RESIDENTIAL BUILDING PERMIT APPLICATION

RE: **12237 Mayapple Drive**, Potential Basement Bedroom

I have reviewed the floor plans in support of Building Permit **B20002610** for a new home at **12237 Mayapple Drive** and noted that there is a proposed full bathroom in the partially finished basement. Please note that this makes it very likely for one or more rooms to be considered bedrooms upon conversion of the entire basement to finished living space and/or installation of an egress window.

LOT 31 PLOT PLAN

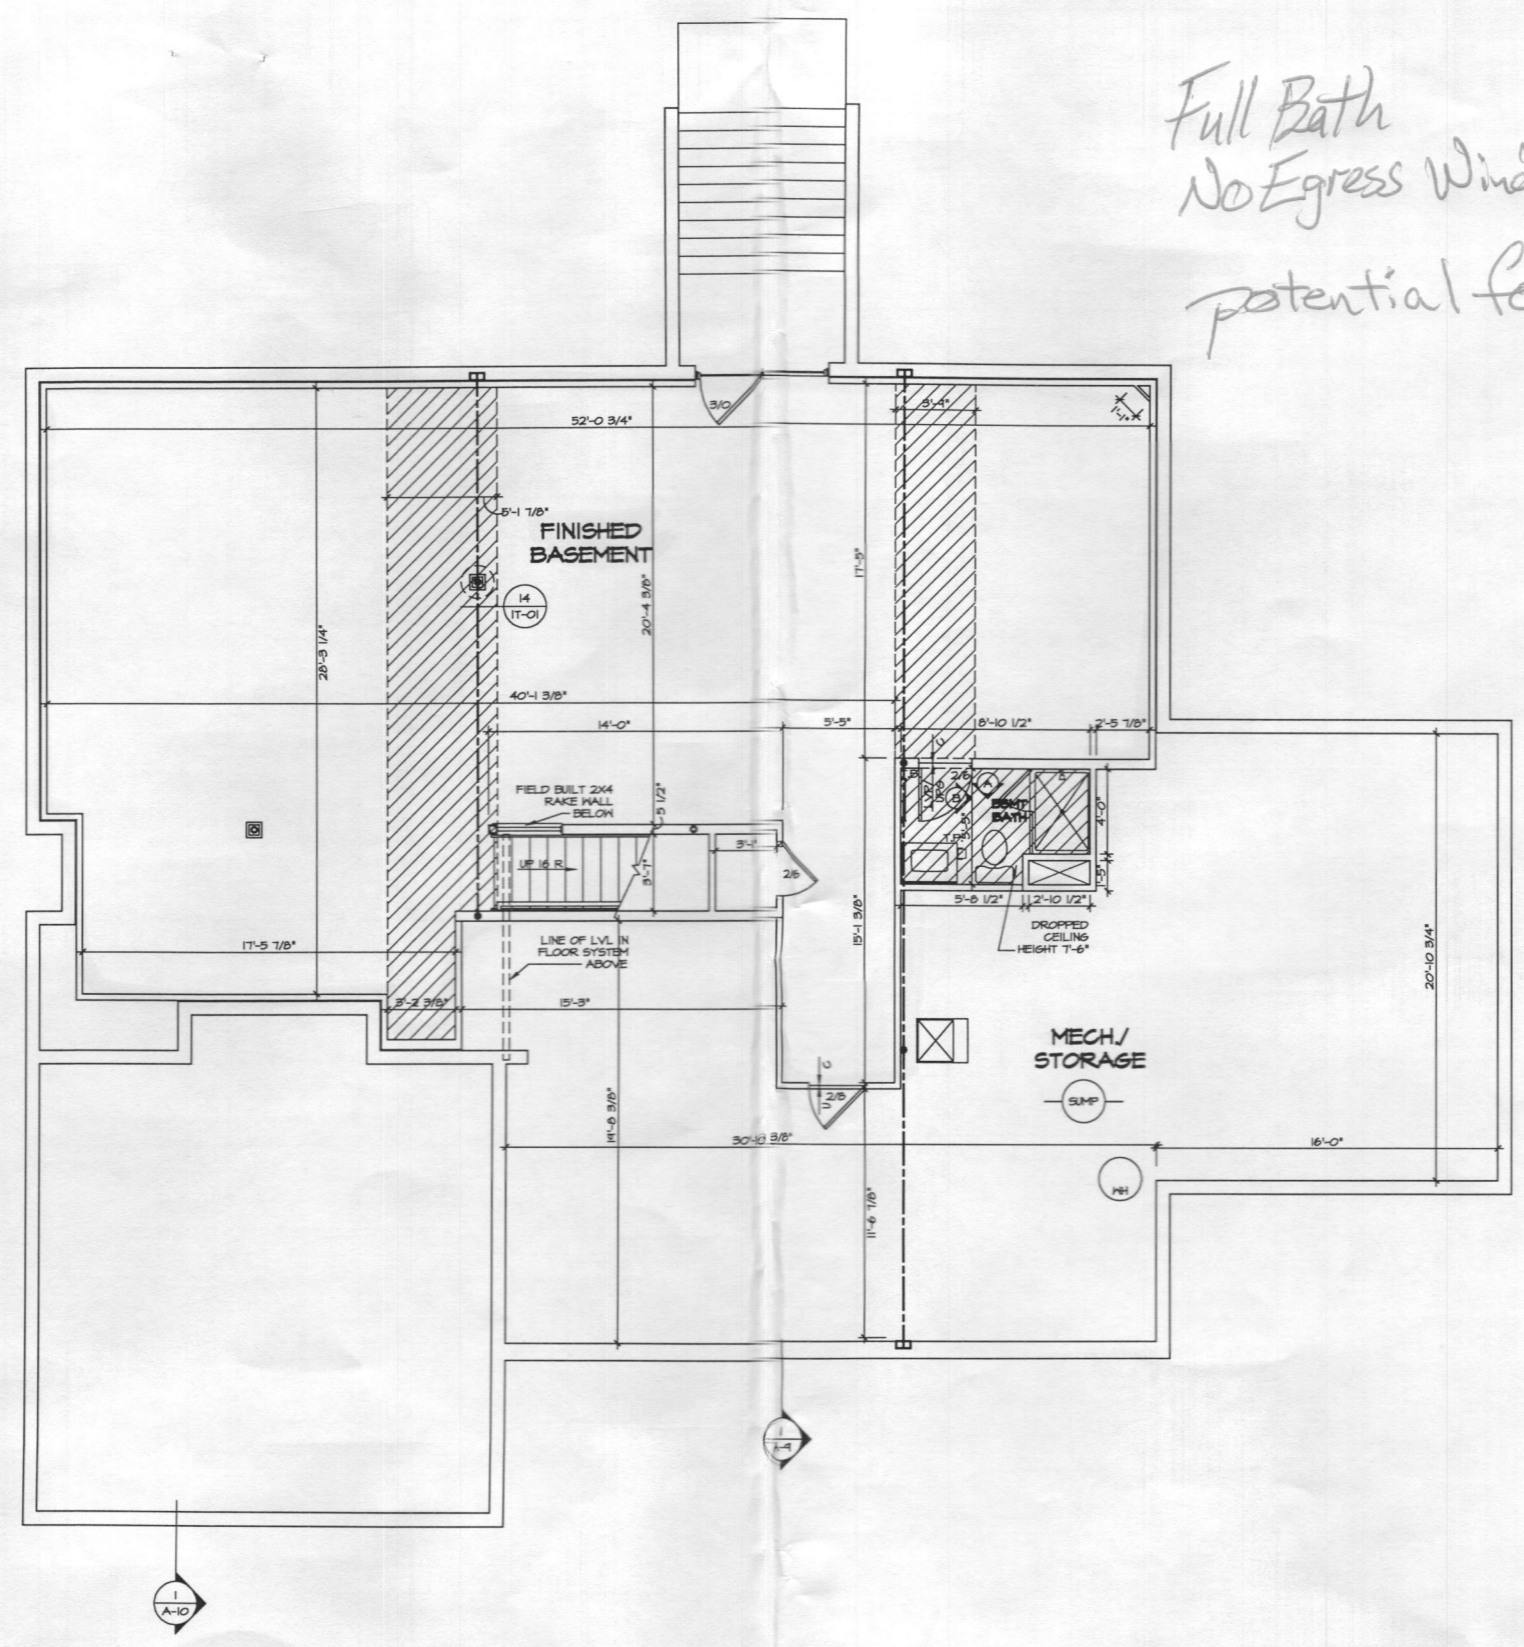
Comments: Revised tank location

*Approved Septic System Plan
Howard County Health Department
S-Redeem SF-D (1st & 2nd Floors
w/ bath in Part D) in Shed basement
Signature 8/26/2020*

SHEET NO.
A-6

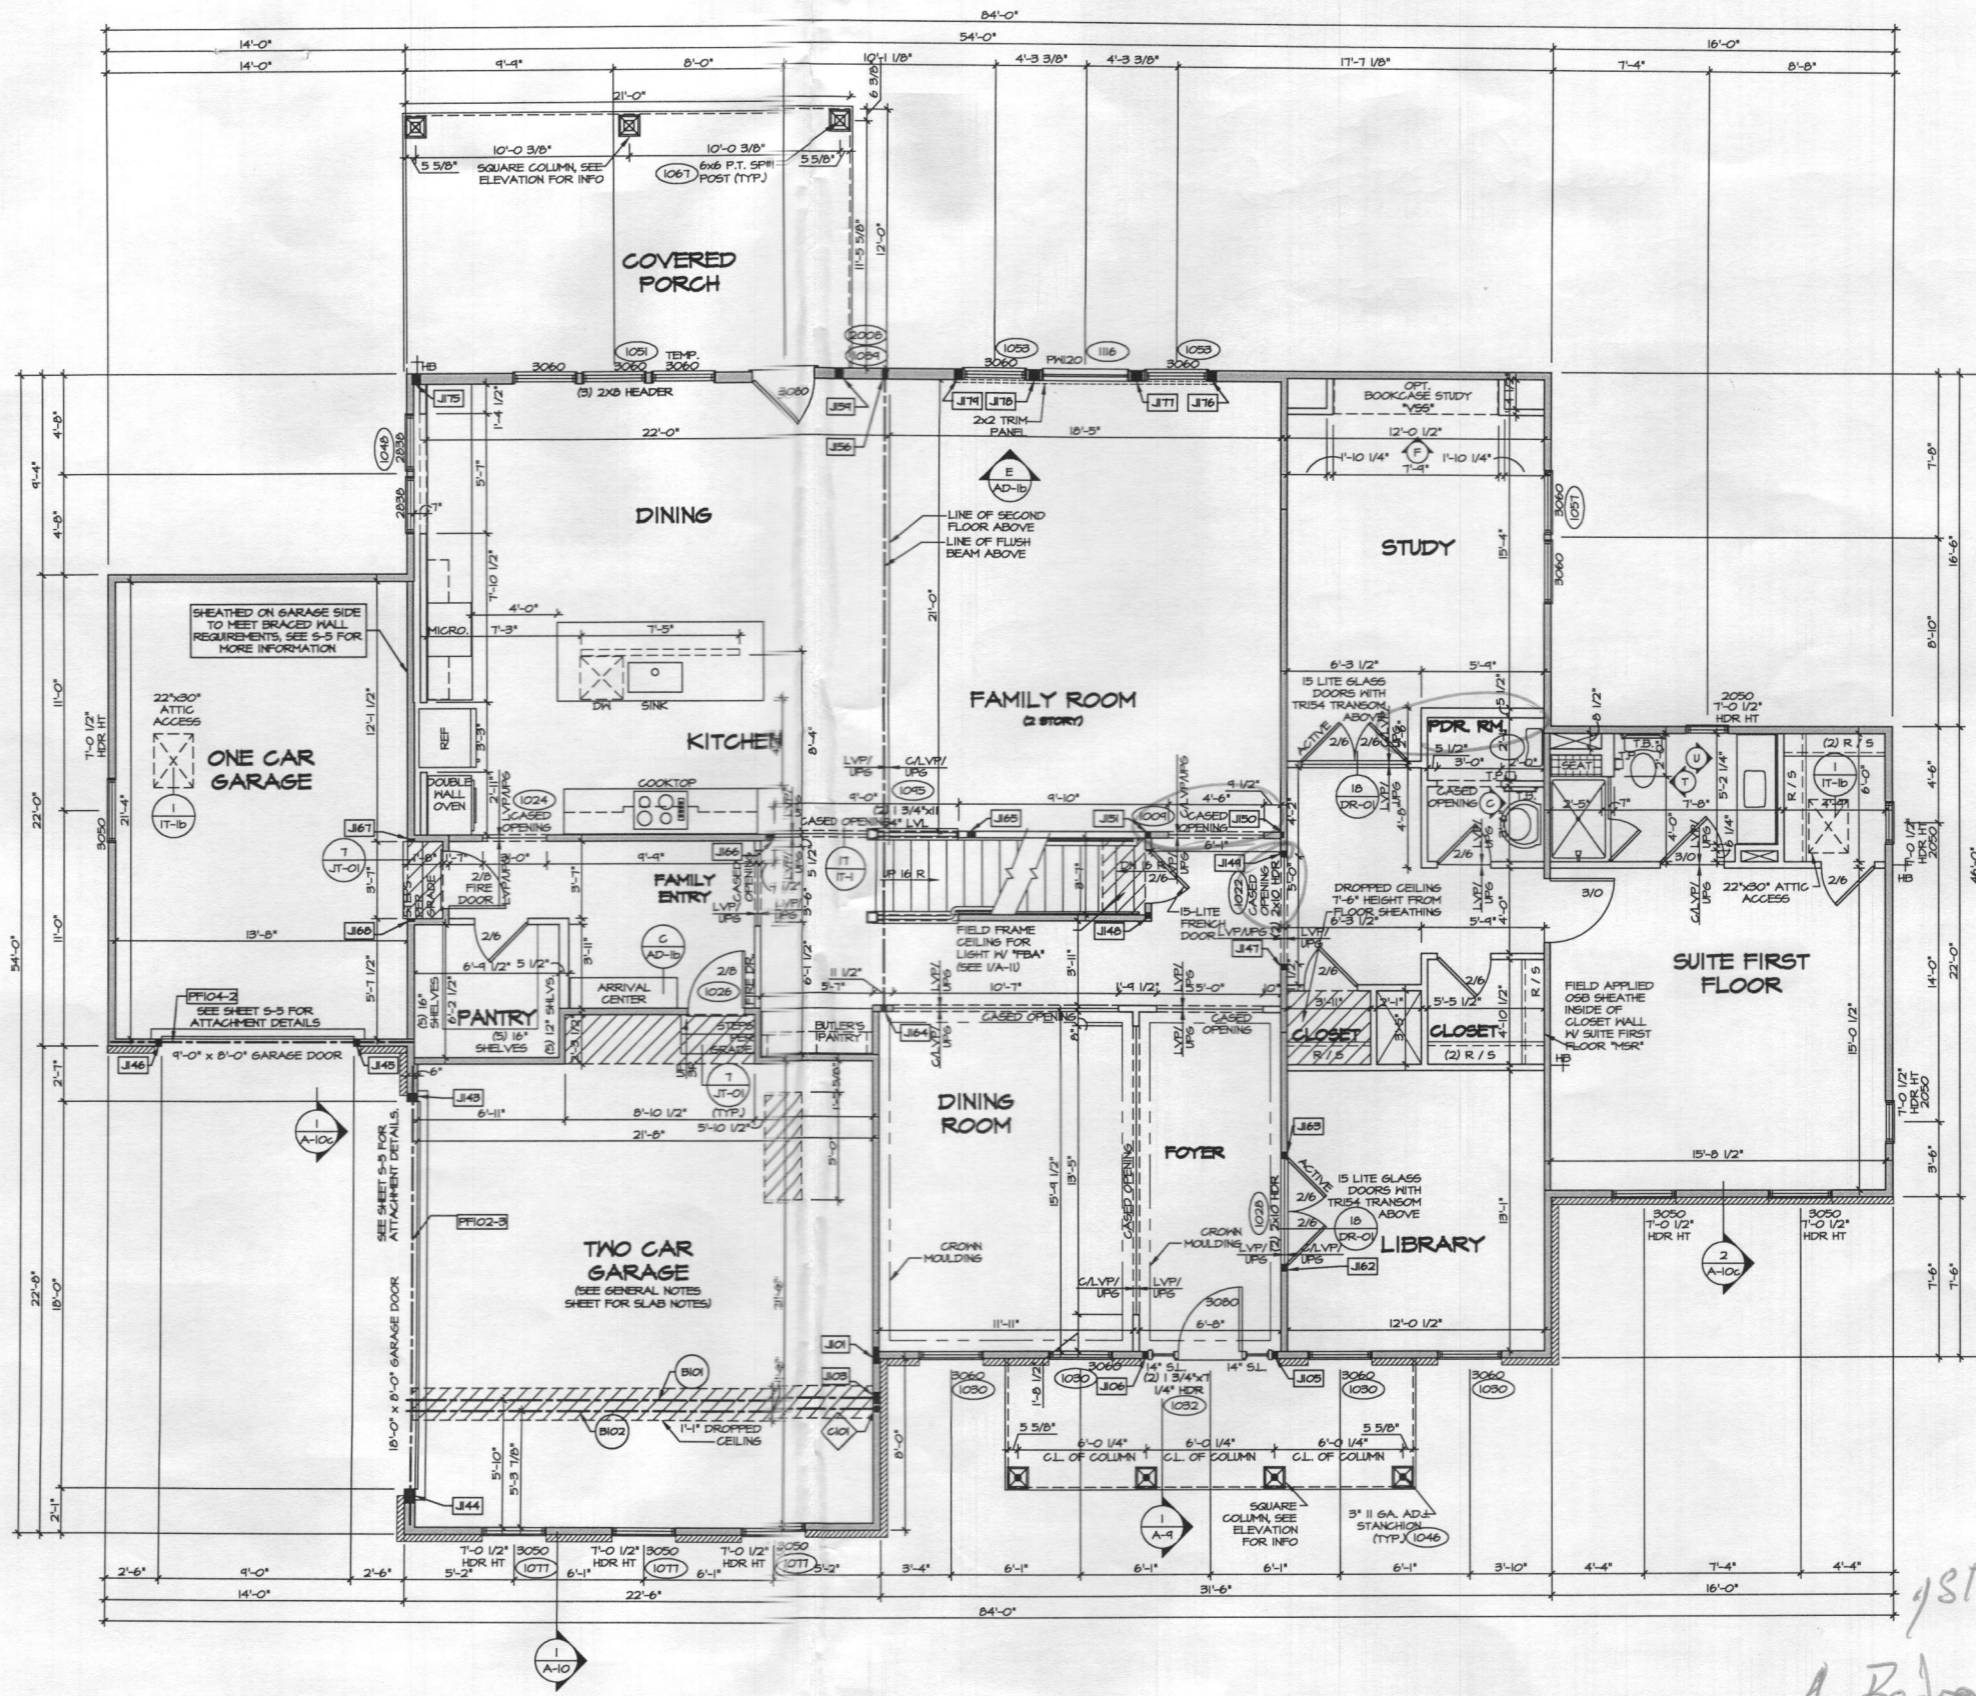
Full Bath
 No Egress Window
 potential for Basement bedroom

The Health Department strongly recommends sizing the onsite sewage disposal system at least one bedroom larger than the existing **five (5)** bedroom design to accommodate a future finished basement. If you choose to only size for the existing design, any future building permit for a finished basement may be placed on hold until the system is upgraded to accommodate the proposed number of bedrooms. This memo will be retained in the Health Department file for future reference.
